RFB NO. 313086 - ADDENDUM NO. 6

### ARCTIC ANIMAL EXHIBIT AND CONCESSIONS

This Addendum is issued to modify, explain or clarify the original Request for Bid (RFB) and is hereby made a part of the RFB. Please attach this Addendum to the RFB. **Bidders must acknowledge all Addenda on the Bid Form.**

C2.3

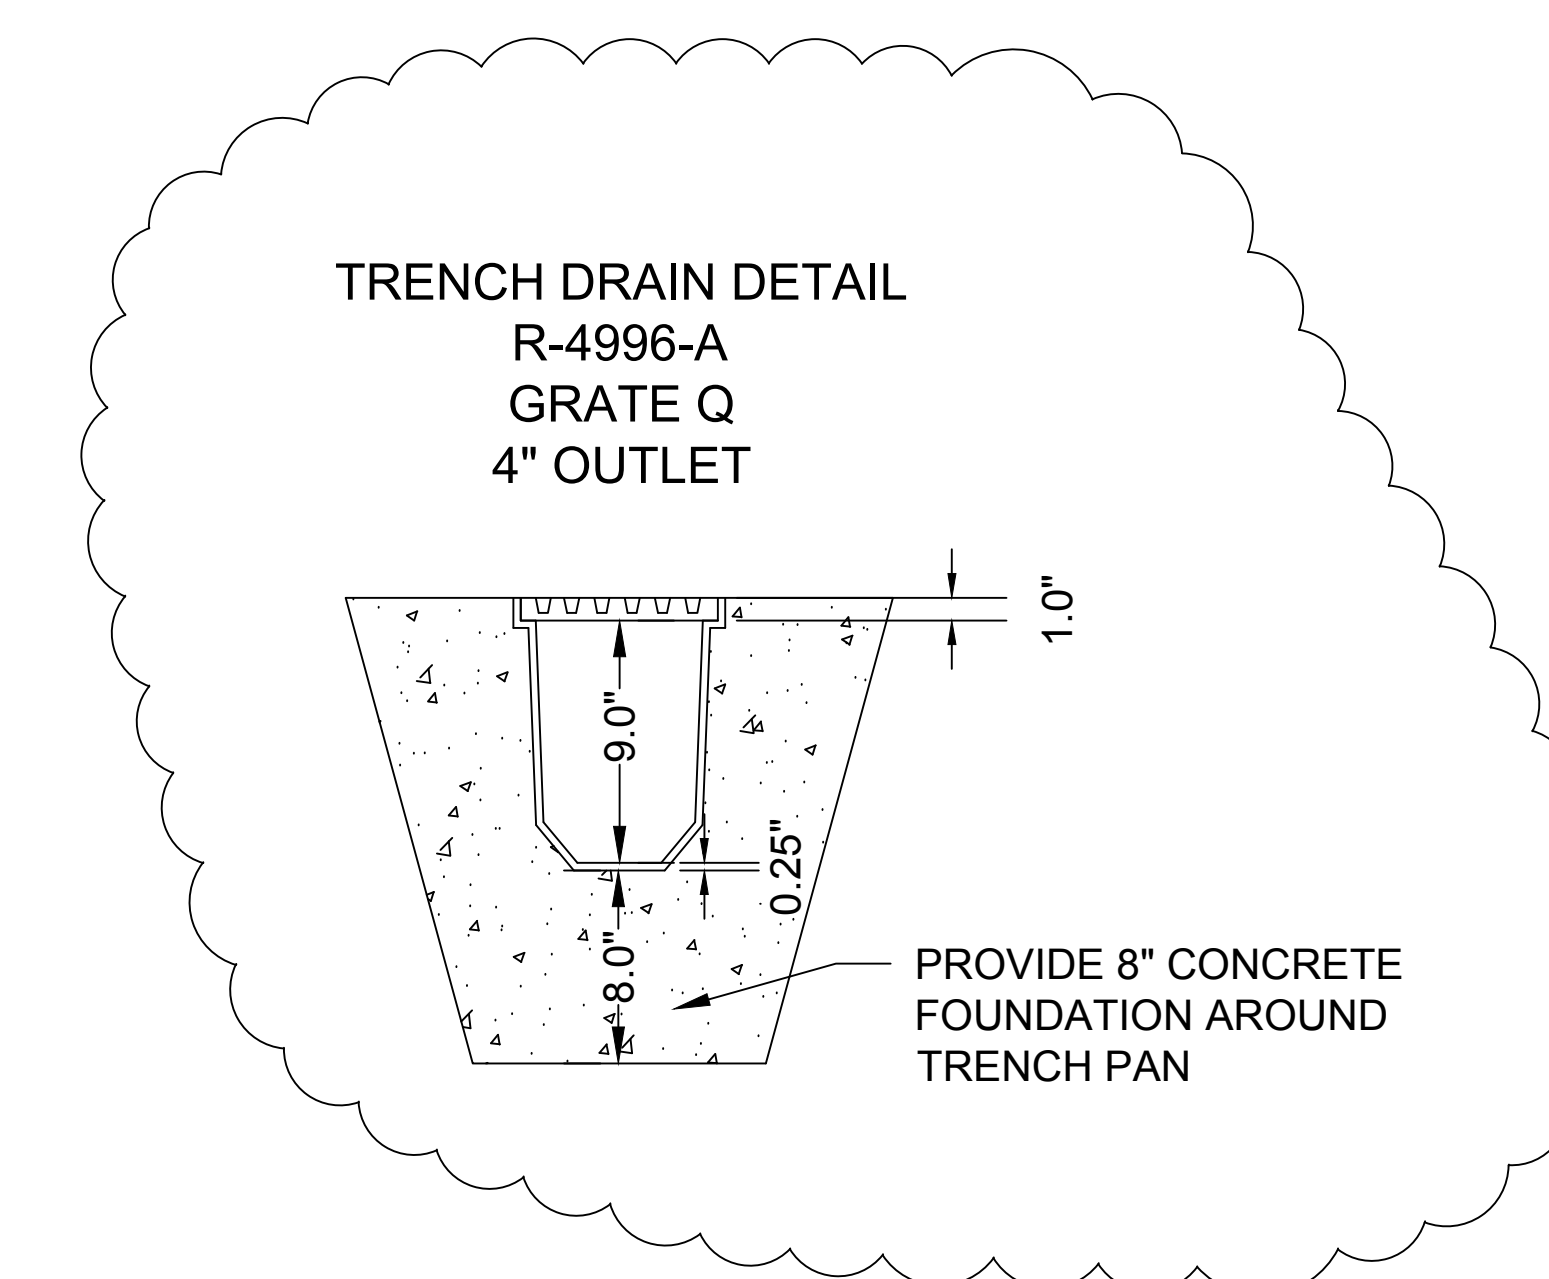
## **5. Sheet C2.3 – Sanitary Pipe Table**

- Pipe 2, Length 197'
- Pipe 3, Length 15', Slope 0.69%
- Pipe 4, Length 32', Slope 0.78%
- Pipe 10, Length 104'
- Pipe 24, Length = 62', Slope 4.20%
- Pipe 27, Slope 5.23%

C2.7

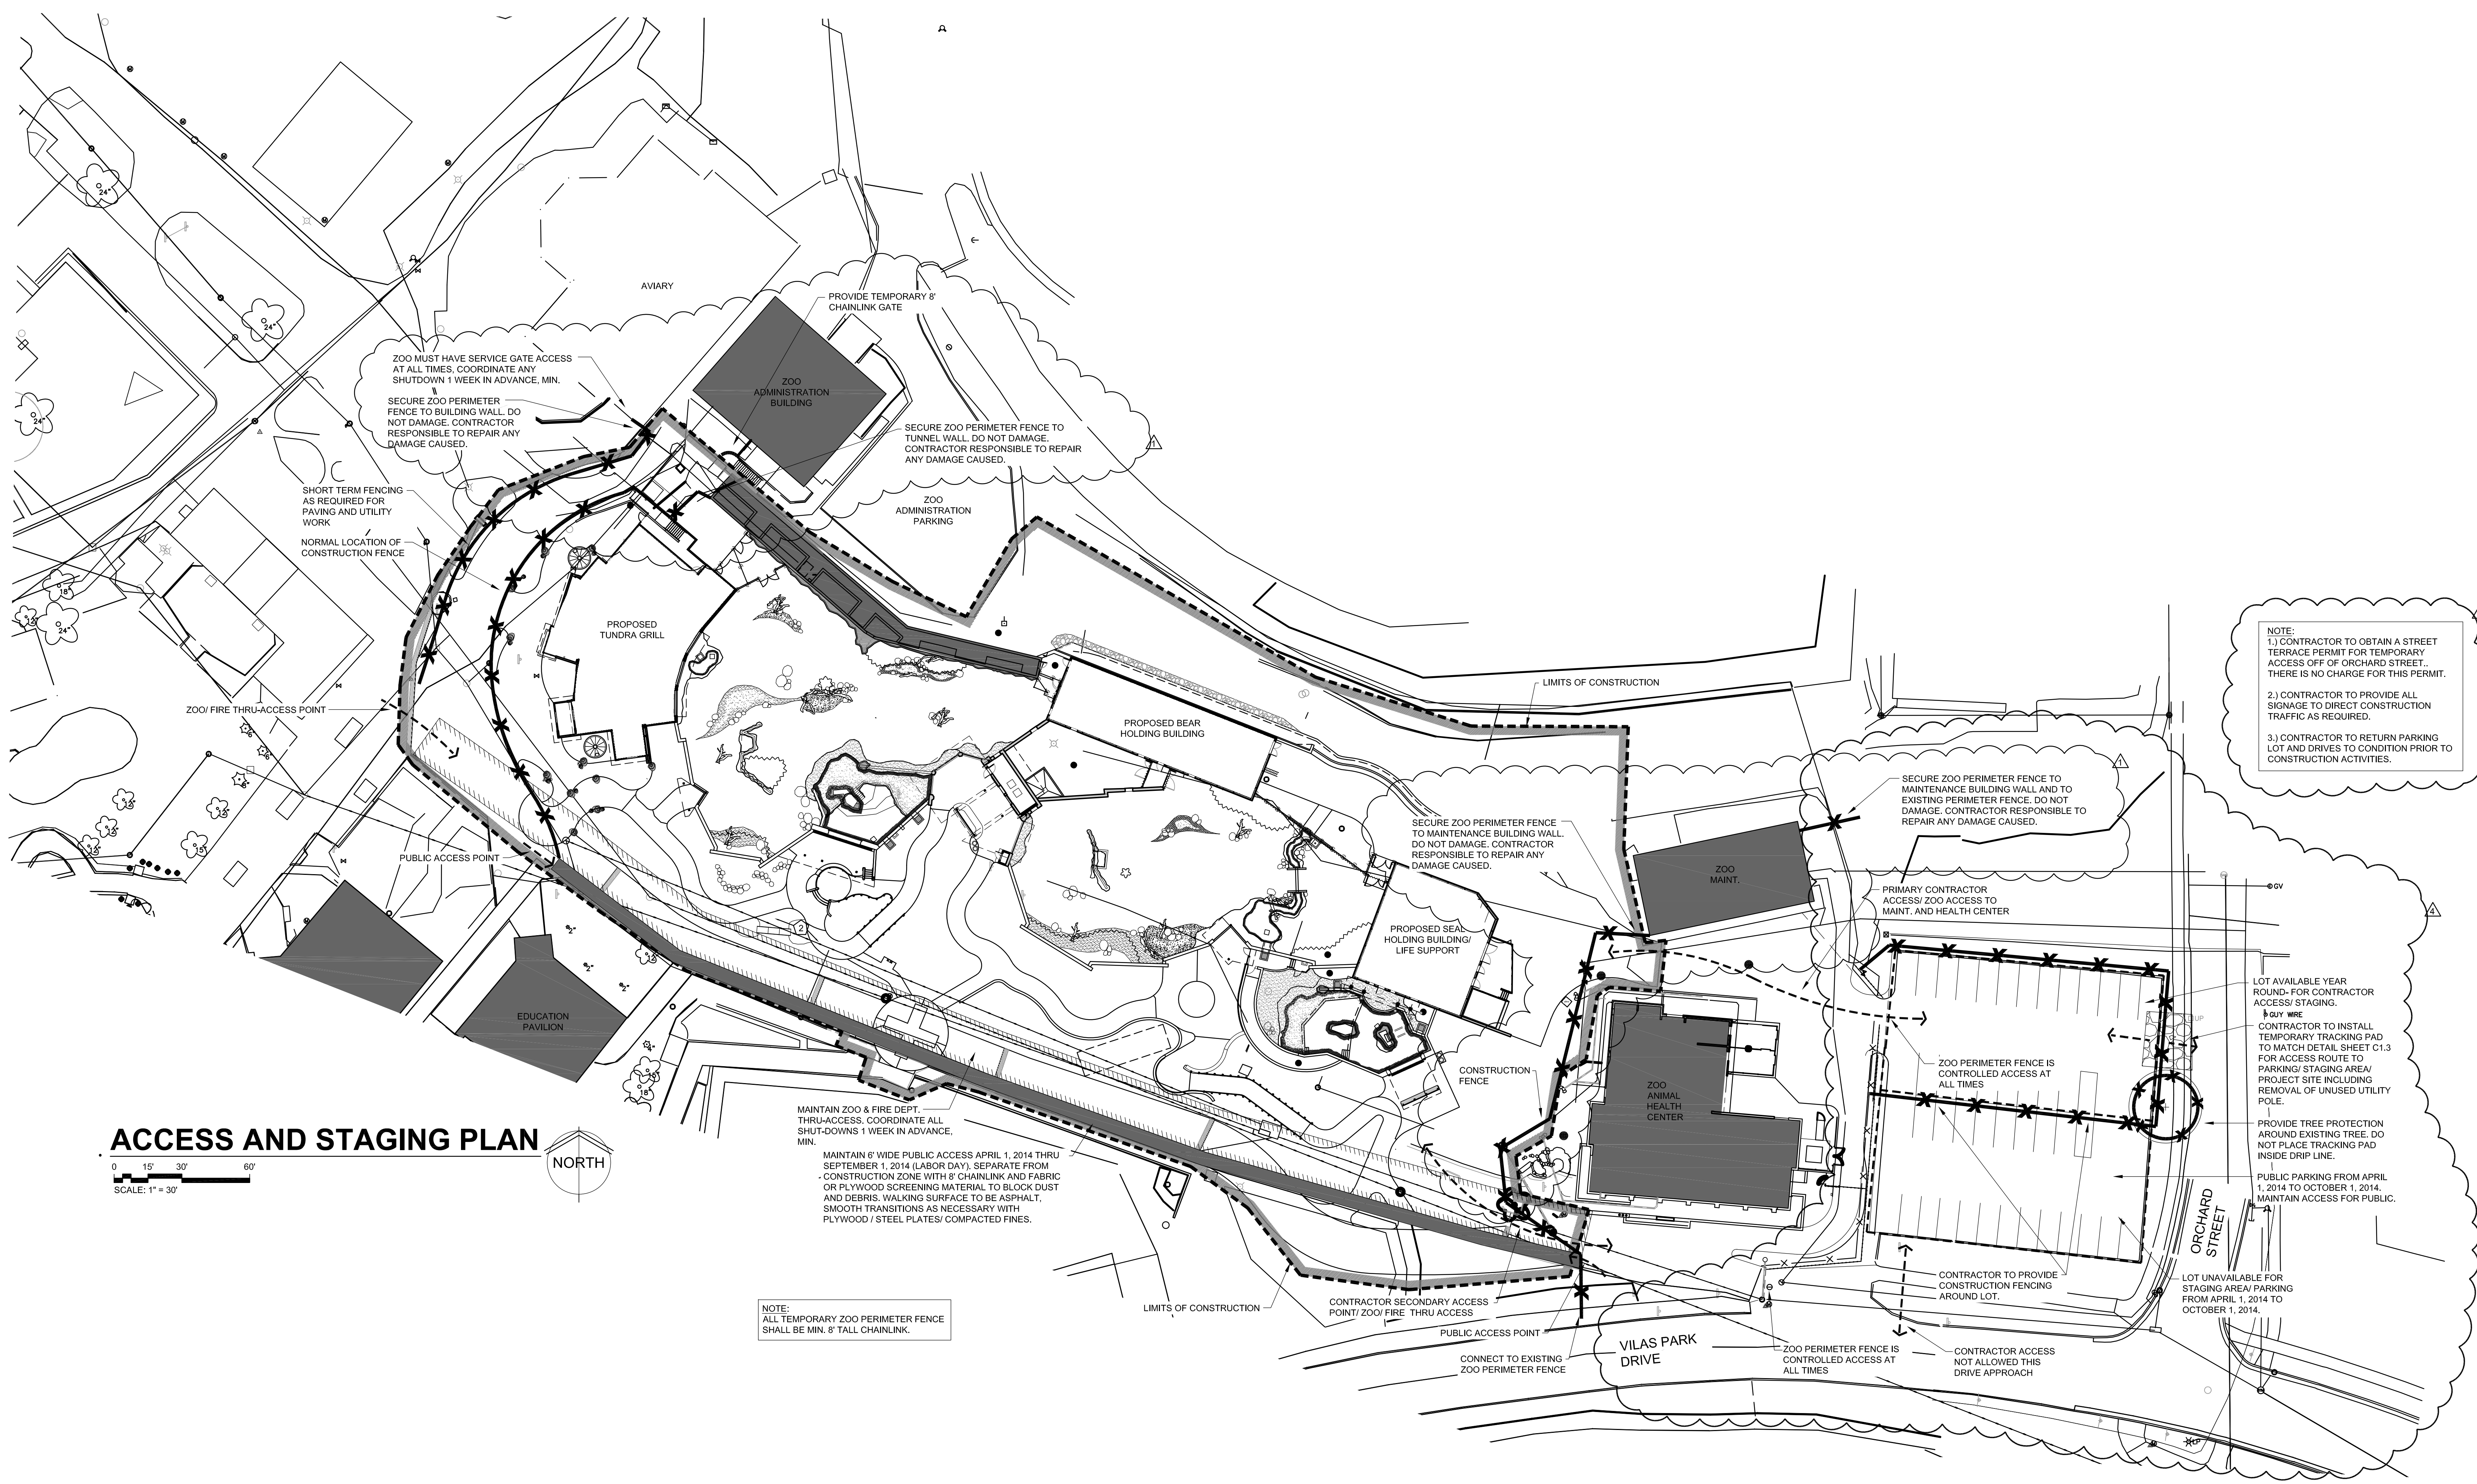
## **6. Sheet C2.7- Storm Water Str. & Pipe Tables**

- ST 2.23, 28 Linear Feet, RIM=106.00
- ST 2.32, 15 Linear Feet, RIM – 107.00, INV OUT 106.25
- Pipe 43, 4 inch PVC
- Pipe 46, 4 inch PVC
- Added Trench Drain Detail

**CS1.0**

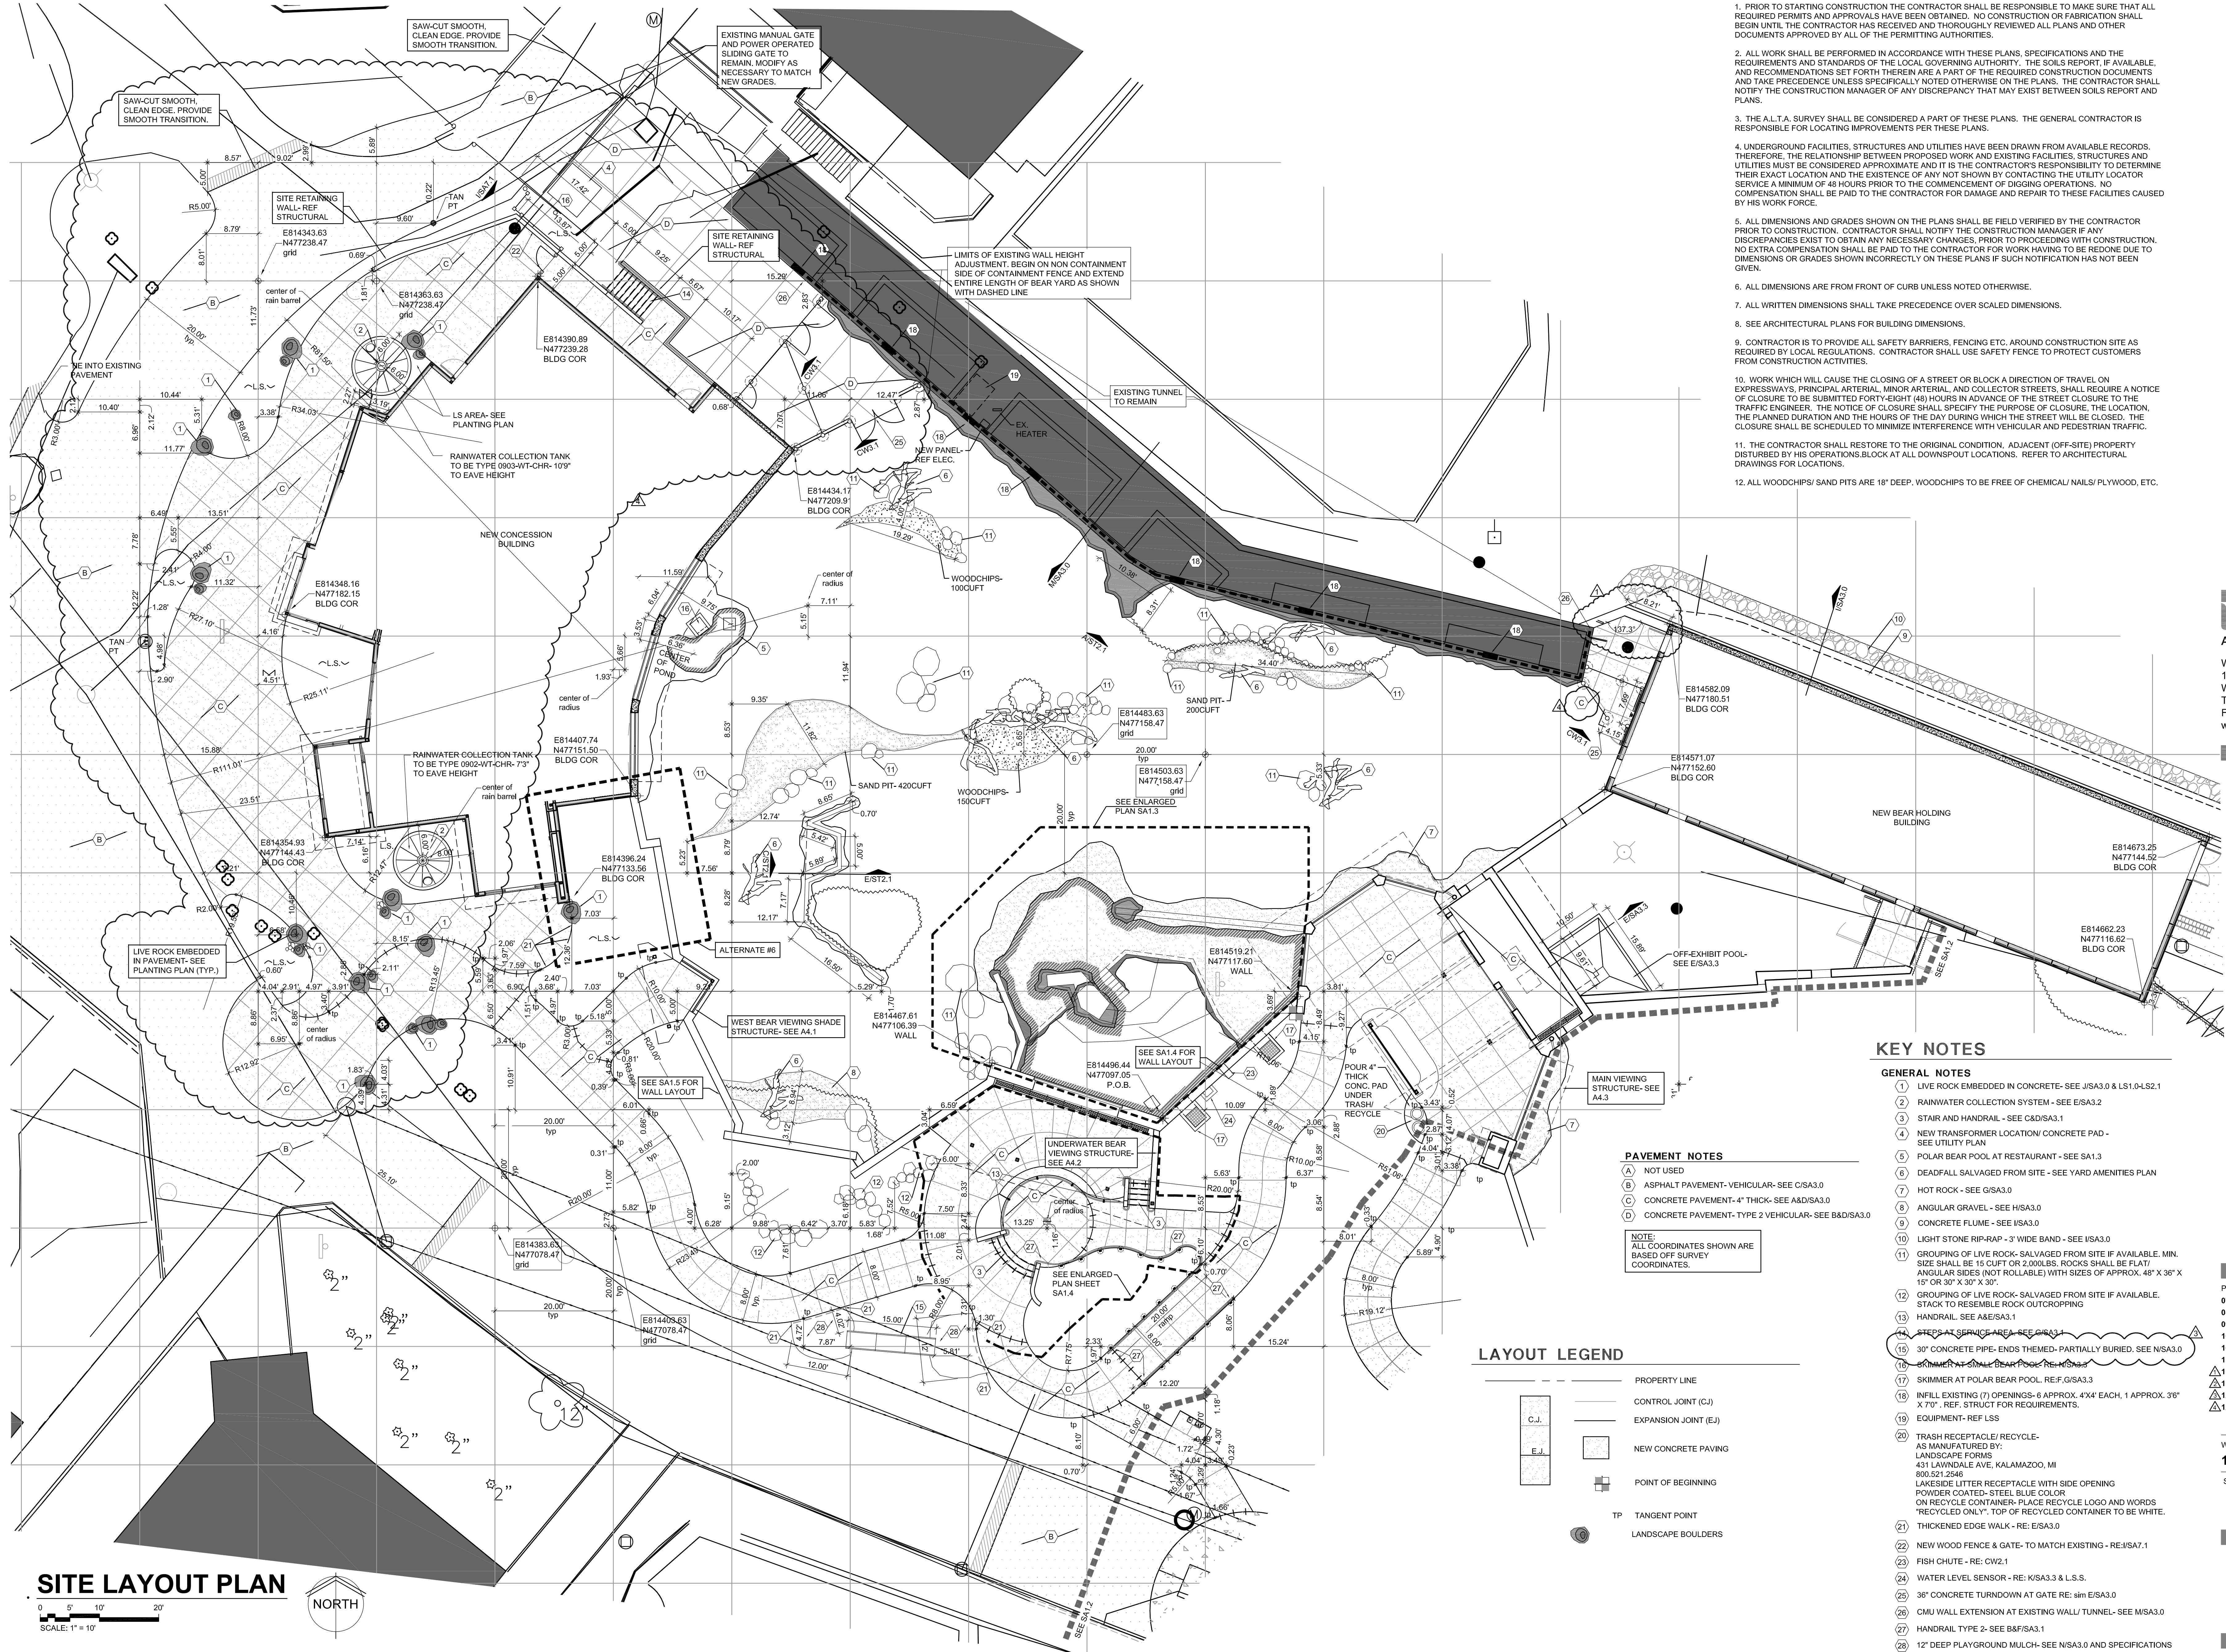
### **8. Sheet CS1.0**

- Modified contractor access/ staging locations.
